Addendum 001

Morgan Hill Butterfield Fire Station

Issued: May 4th, 2023

1
M5.3
 PROJECT NUMBER: 211101
 SHEET TITLE: HVAC DETAILS

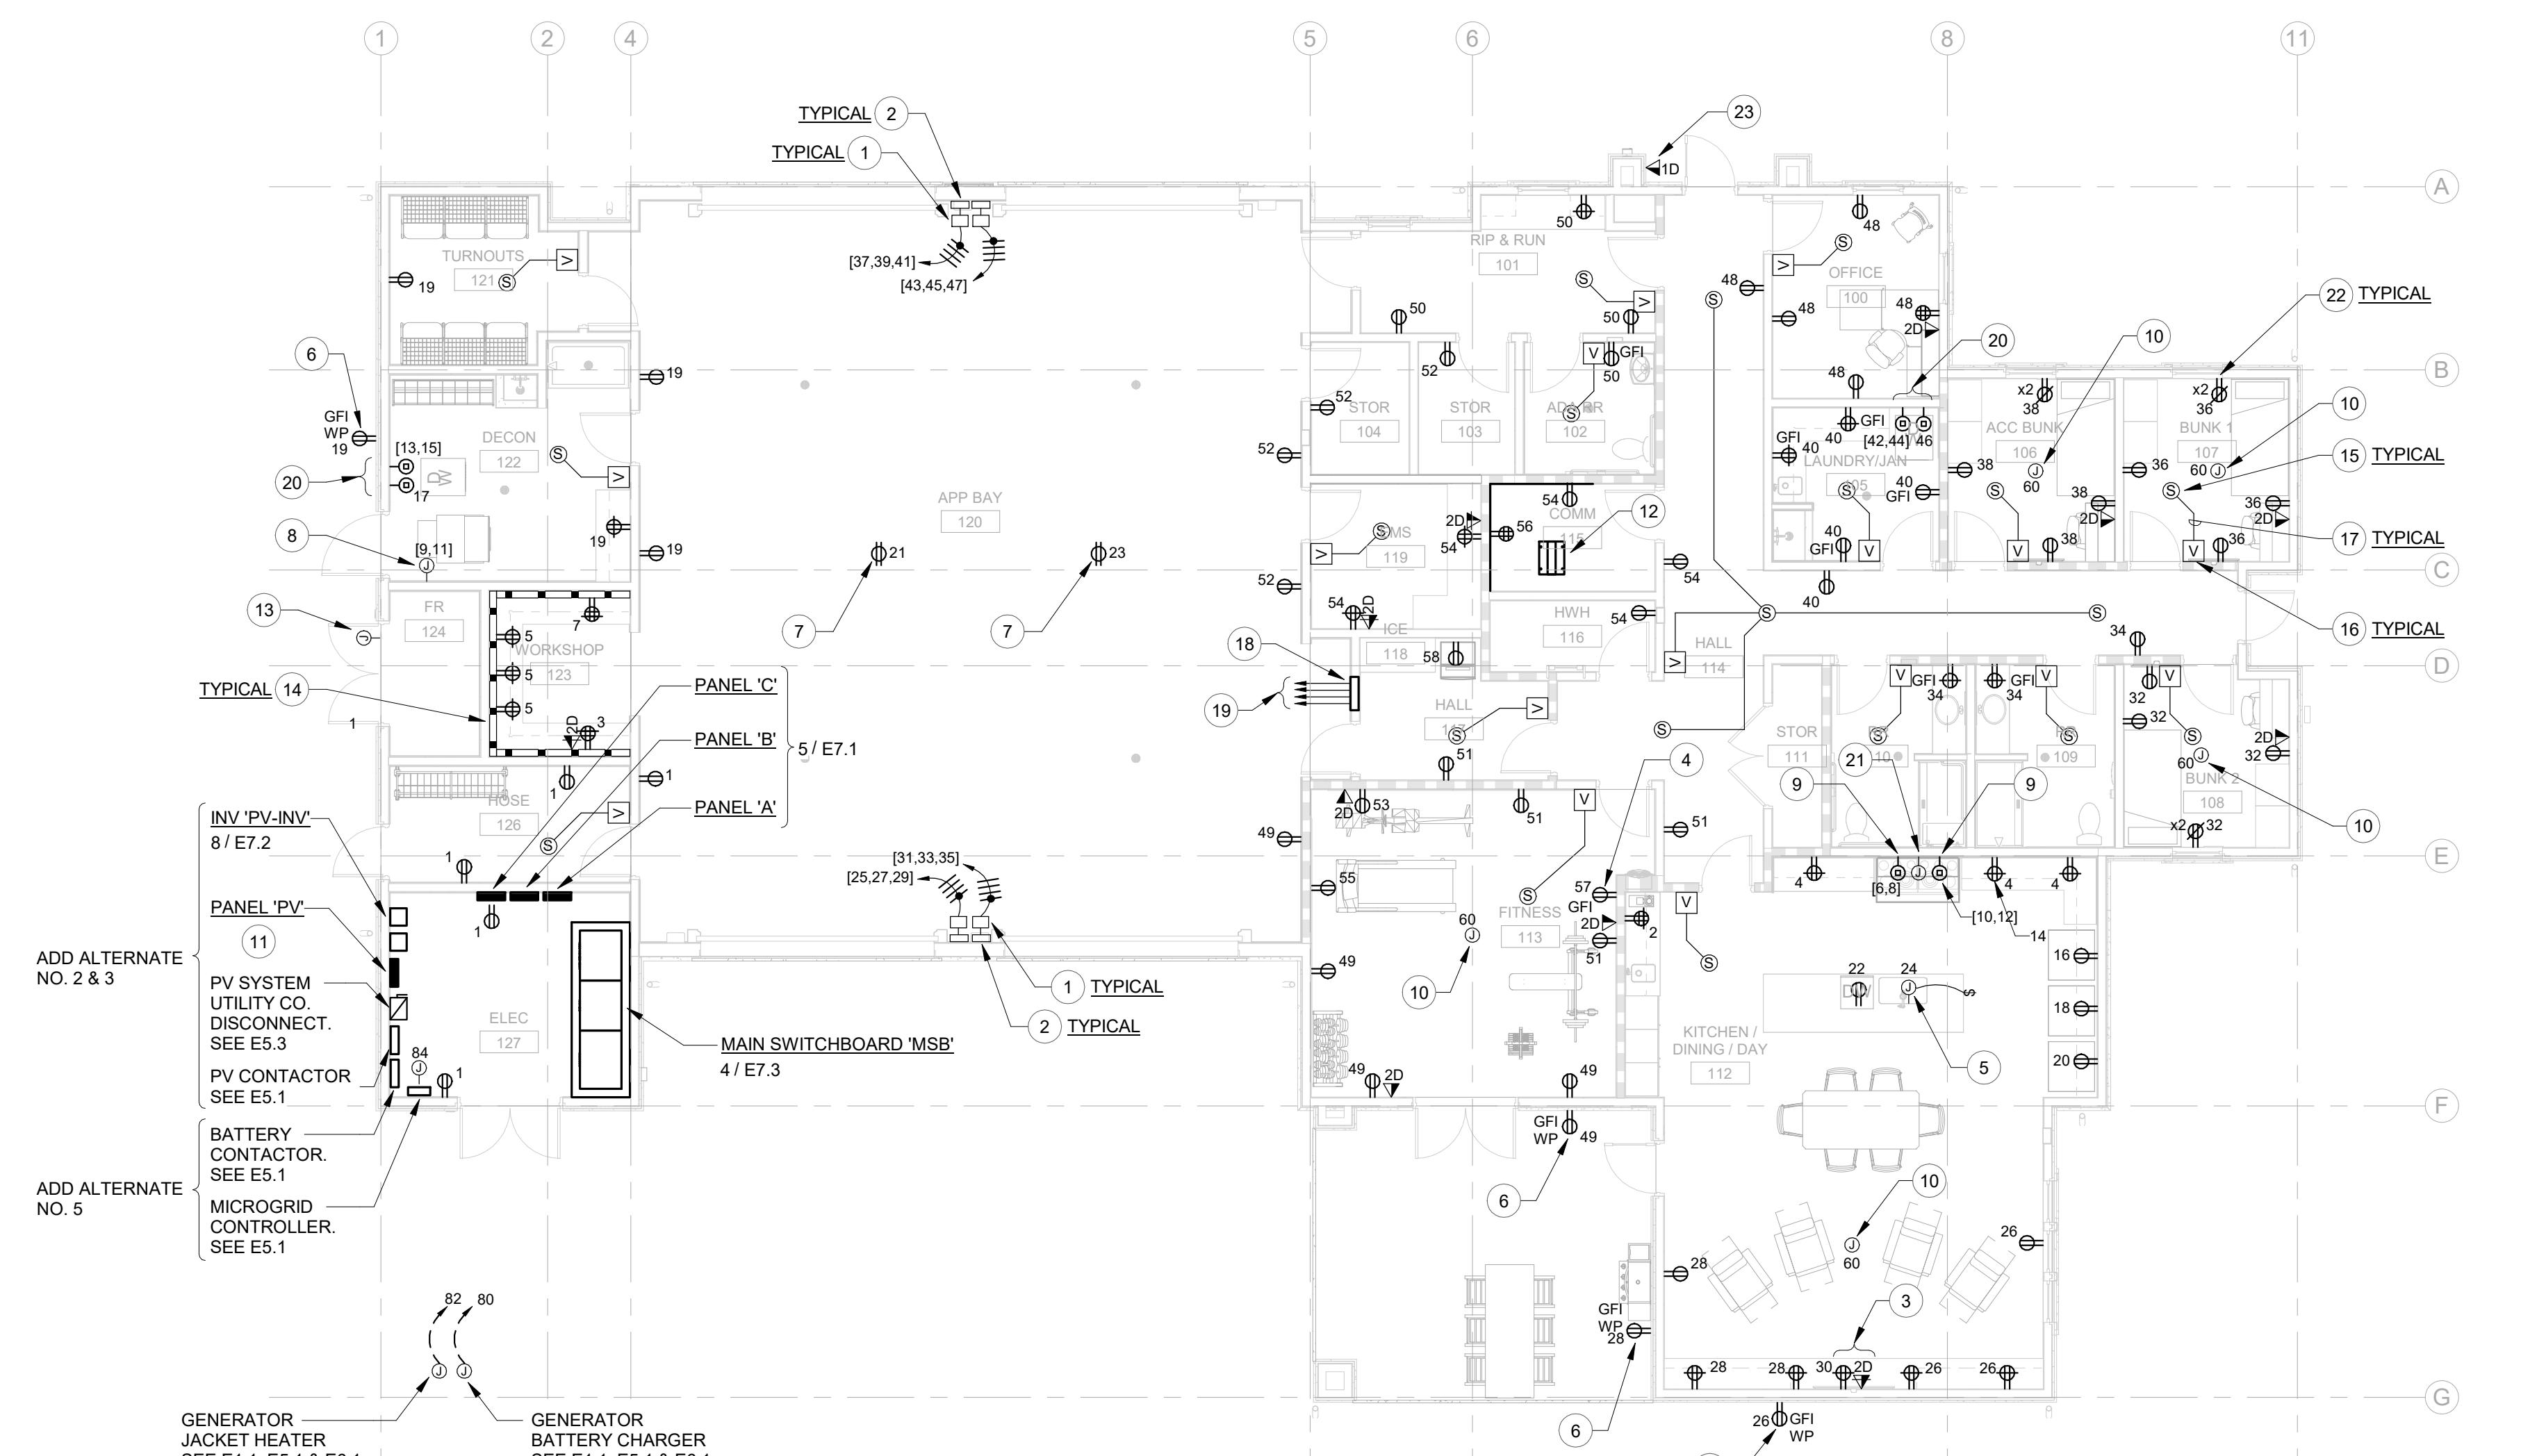
For the outdoor VRF units on M2.1, please clarify if the piping to these units is to be under slab or surface mounted on concrete.

Are VRF-CU-1 and 2 supposed to be next to the building, or are they to be away from the building as graphically shown on sheet M2.1? If they are to be away from the building, please provide a detail for buried refrigeration lines at those locations where the refrigeration lines will be under concrete walkway, and how they are to enter the building.

Piping to VRF units is to be under slab, see details on sheet M5.3 for buried refrigeration lines.

The units are to be installed in locations shown on site plans. See details on sheet M5.3 for buried refrigeration lines.
